January 20, 2022  
File No. 05.00043654.60

Re: Site Remediation File No. SR-26-0934A/Formerly RIDEM Case No. 95-022  
Former Tidewater Facility  
200 Taft Street  
Pawtucket, Rhode Island

### CRMC ASSENT MODIFICATION

**ALTERNATIVE REVEMENT LAYOUT PLAN**

**D1** WALL SECTION (STA. 5+75)  
SCALE: 1" = 10'

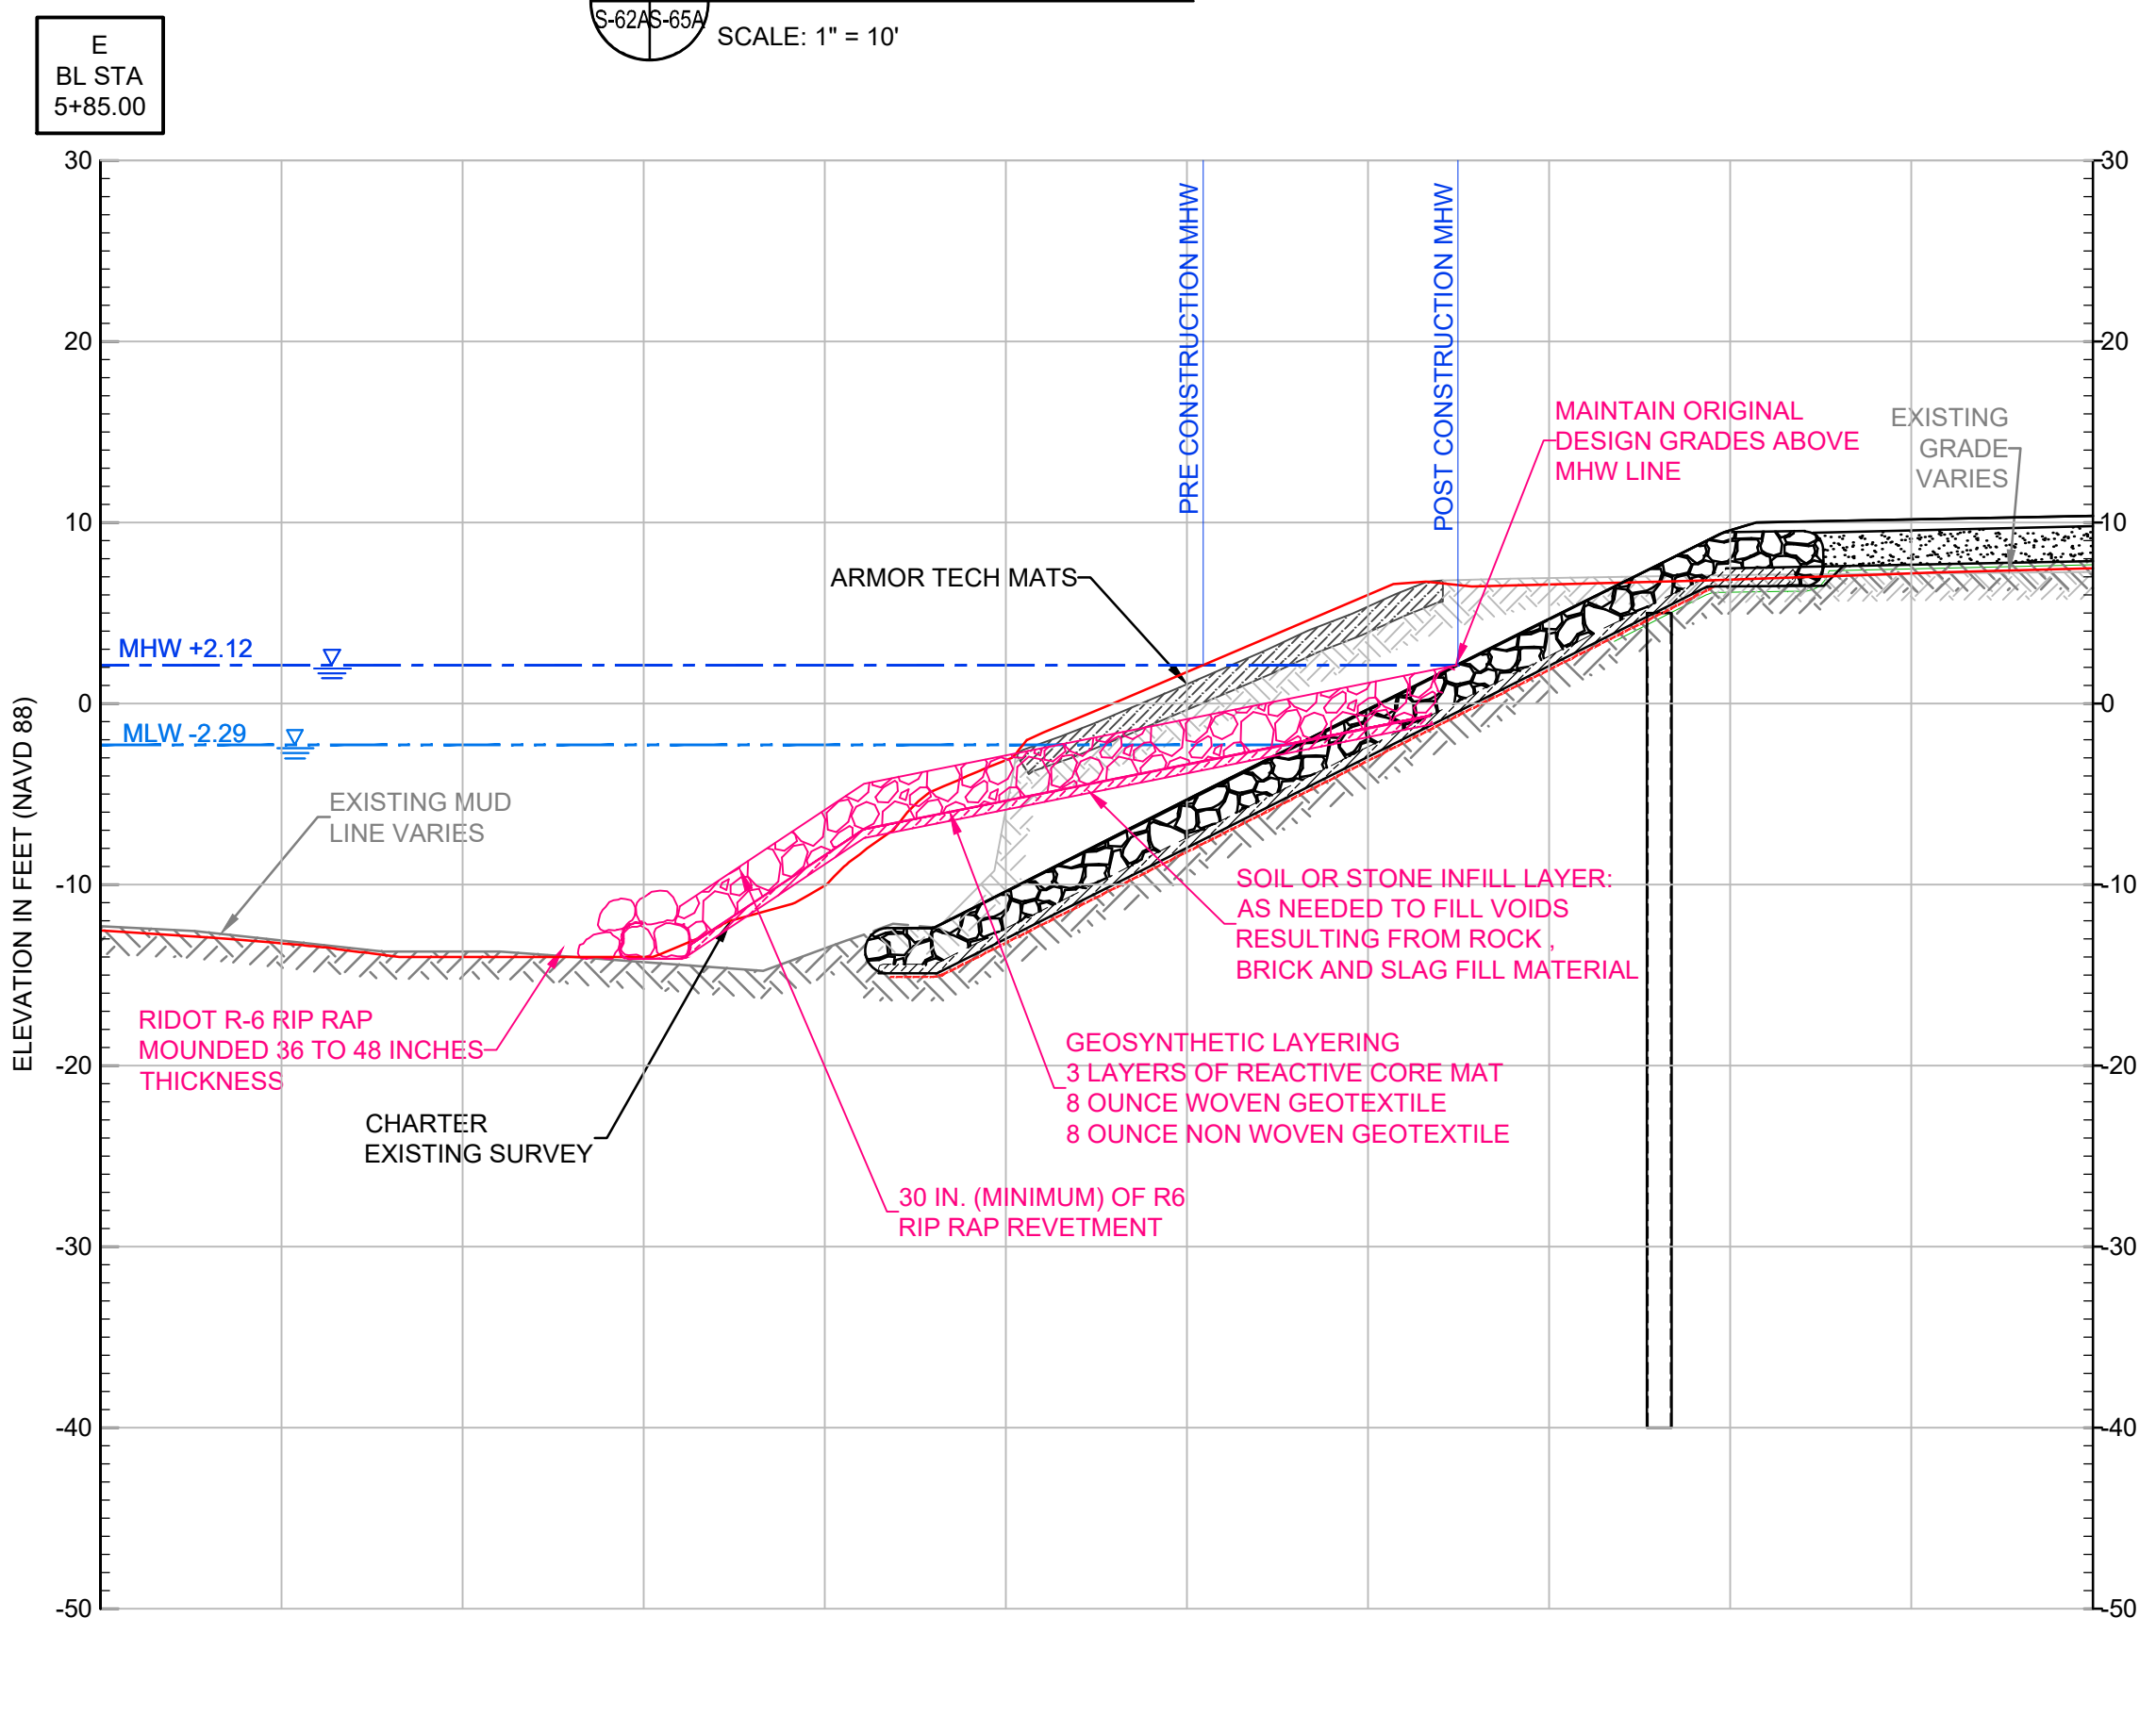
2. The approved site plans shall be those titled "Former Tidewater Facility, Pawtucket, Rhode Island, Contract Document Phase 4 and 4, Alternative Revetment Layout Plan...", sheets 1 and 2 (Drawing S-62A and S-65A) dated January 2022, by GZA Inc.. Except as stipulated or modified herein, all details and specifications thereon shall be strictly adhered to. Any and all changes require written approval from this office.

This work is located in the Seekonk River located at 200 Taft Street in Pawtucket, Rhode Island. The revised work is shown on the enclosed plans titled "FORMER TIDEWATER FACILITY PAWTUCKET RHODE ISLAND CONTRACT DOCUMENTS PHASE 4 & 5 ALTERNATIVE REVETMENT LAYOUT PLAN" on two sheets dated "JANUARY 2022".
